This gallery shows some pictures of bad solderings - they should prevent you from making the same errors (feel free to add even more pictures here!)

2008/12/01 home:skills:bad_solderings_gallery http://wiki.midibox.org/doku.php?id=home:skills:bad_solderings_gallery&rev=1228123119
09:18

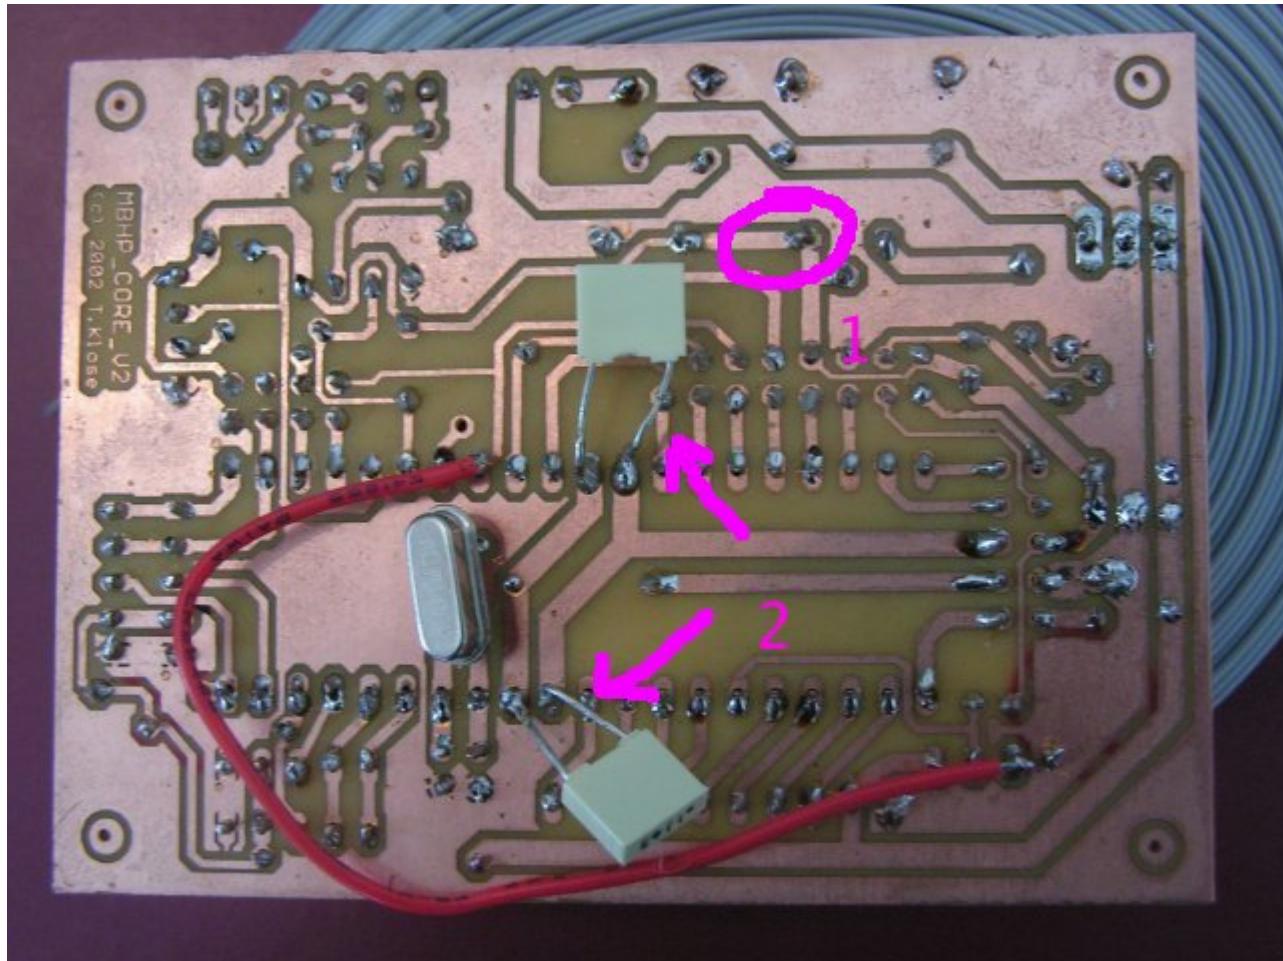
1: The core module has some badly soldered connections (loose), which could lead to failures. There are also missing solderings (e.g. 33pF cap below crystal). It makes sense to solder each pad again, the [Soldering](#) guide in the Wiki gives some useful tips

2: The legs of the caps should be cut, otherwise they can cause a short circuit which can damage the PIC!

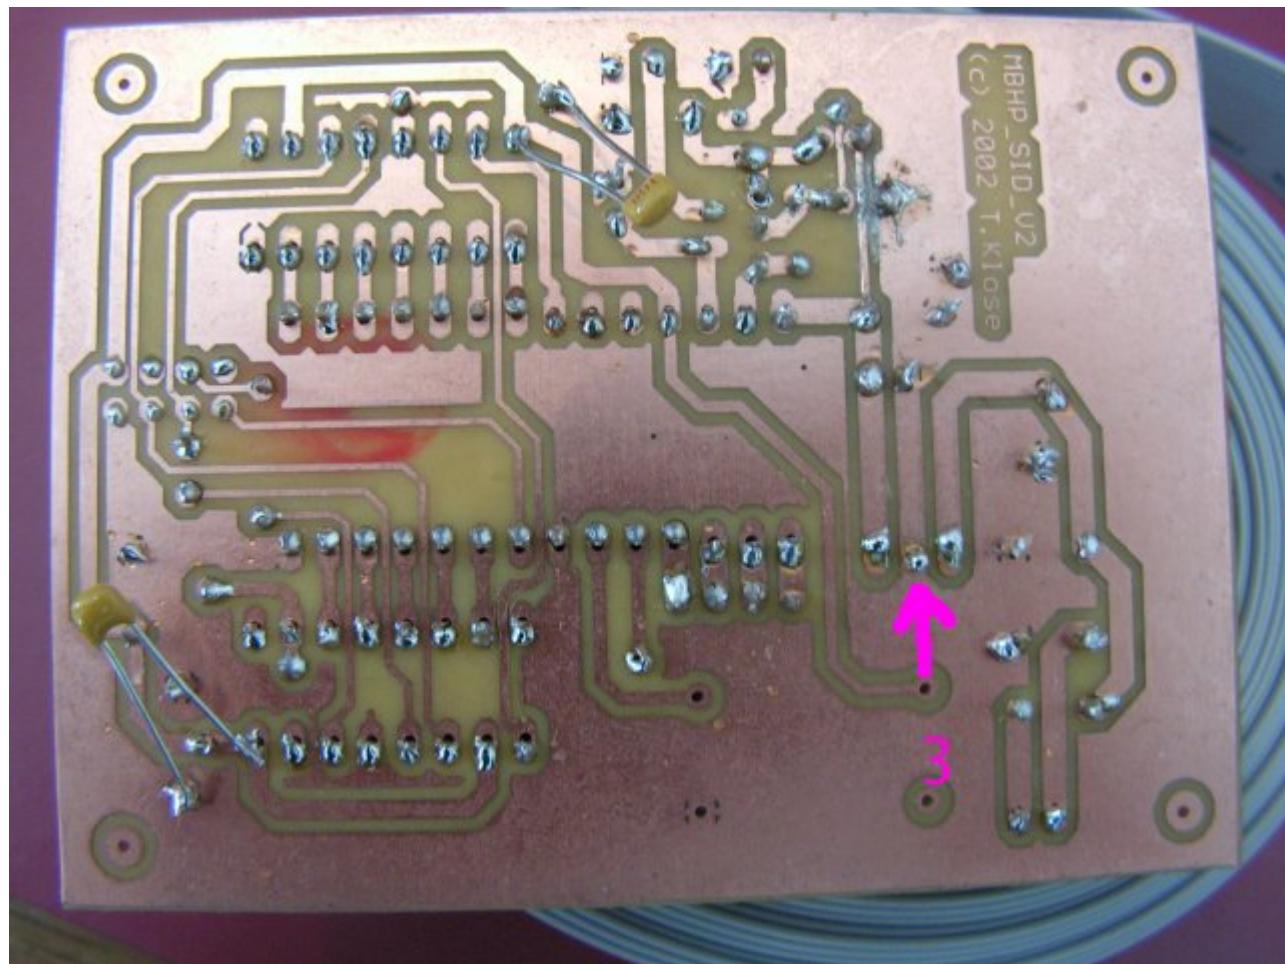
3: This seems to be a bad ground connection directly at the 78xx - it can lead to the wrong voltage. Here the same: just solder the pads again, it will help

And same as above: the long cap legs need to be cut, the danger of shorting out is too high!
